NOTICE OF ALLOWANCE AND FEE(S) DUE

APPLICATION NO.	FILING DATE	FIRST NAMED INVENTOR	ATTORNEY DOCKET NO.	CONFIRMATION NO.
29/729,288	03/25/2020	David Buse	2599-272	7640

TITLE OF INVENTION: FLUID VIAL

FIG. 1 (left), FIG. 5 (right)

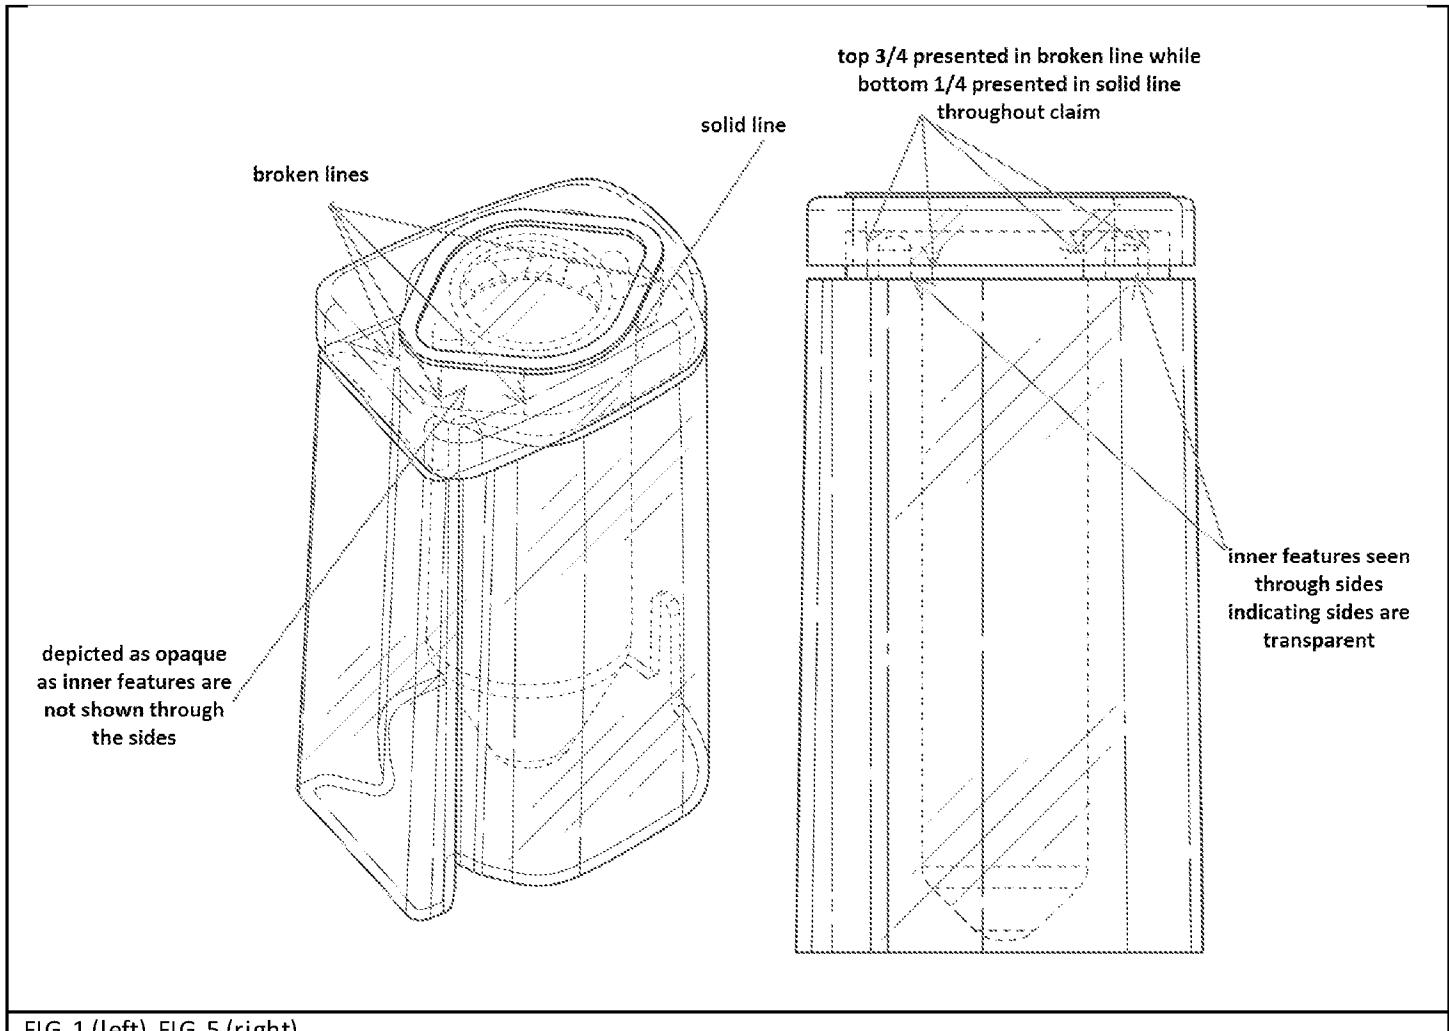
b. The sides of the lemon-shaped inner feature are shown inconsistently in FIG. 1.

solid lines, while in FIG. 1 the sides are seen in only broken lines or only solid line.

Additionally, the transparency of these features is unclear, as in FIG. 1 they are presented as opaque, while throughout the rest of the claim they are presented as transparent. See annotated drawings on next page.

FIG. 1

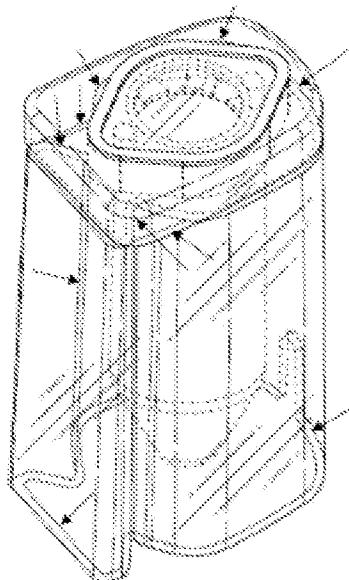
There are portions of the article shown in broken lines while other figure views depict these same portions in solid line. It is possible the broken lines seen in the drawings are intending to depict claimed portions of the article which are seen through transparent planes. However, the function of broken lines in this way causes an inconsistency as the claimed portions of the article cannot be determined. The function of broken lines in this way further confuses the intention of the applicant when attempting to understand the inner features and pencil-shaped structure within the article; it is unclear if these features are depicted in broken lines because

Broken lines, or portions of broken lines, in FIG. 1 that are visible as solid lines in other figures have been changed to solid lines. In the annotated version of FIG. 1 below, arrows point to lines that have been added or that have been converted from dashed to solid so as to be consistent with the other figures.

FIG. 5 (left), FIG. 1 (middle), FIG. 4 (right)

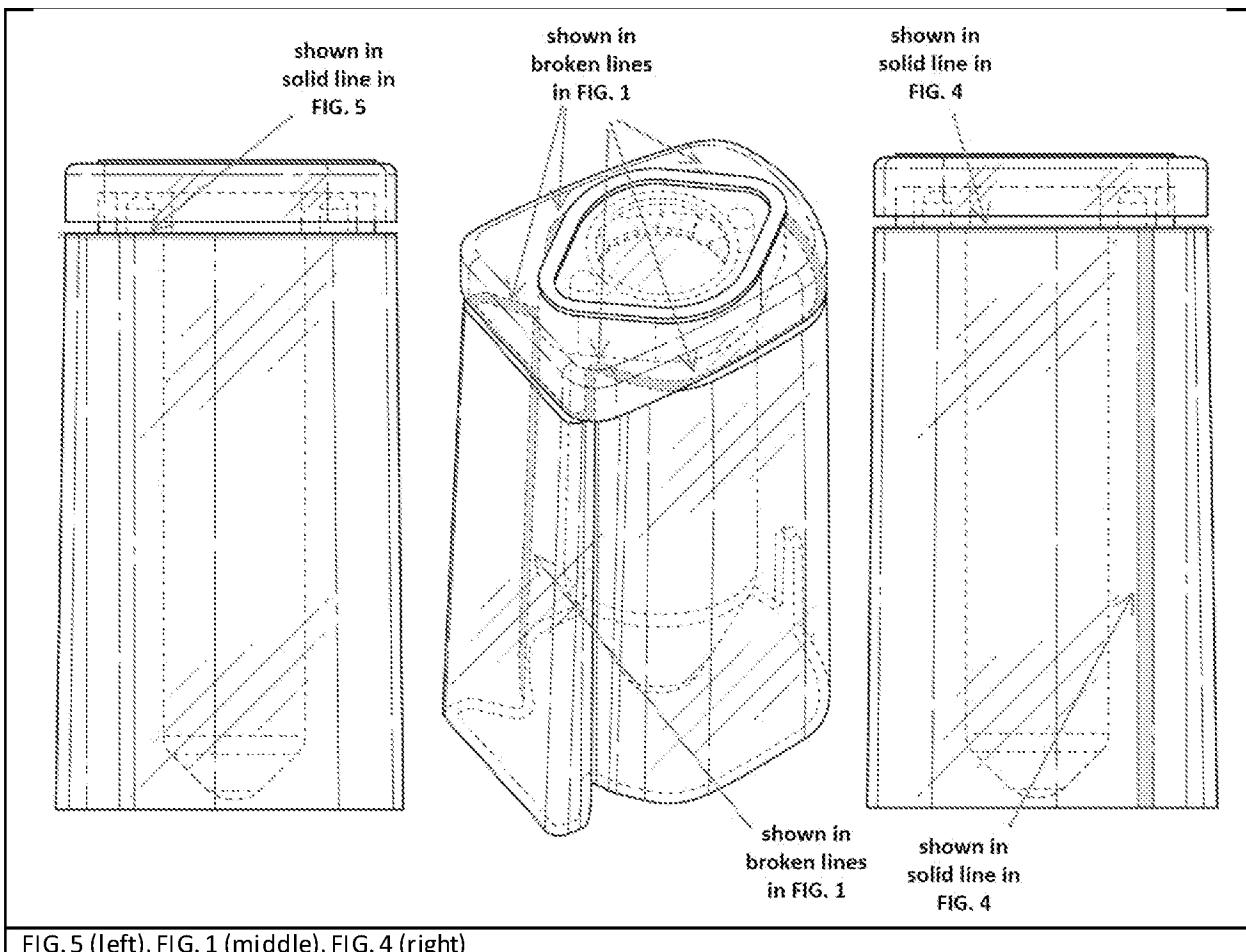
inner features and pencil-shaped structure within the article; it is unclear if these features are depicted in broken lines because they have been removed from the claim, or if they are displayed in broken lines due to being seen through a transparent surface. **Any portion of the structure that is intended to be claimed should be visible in solid lines (or contour lines where appropriate) through the transparent surfaces of the article.**
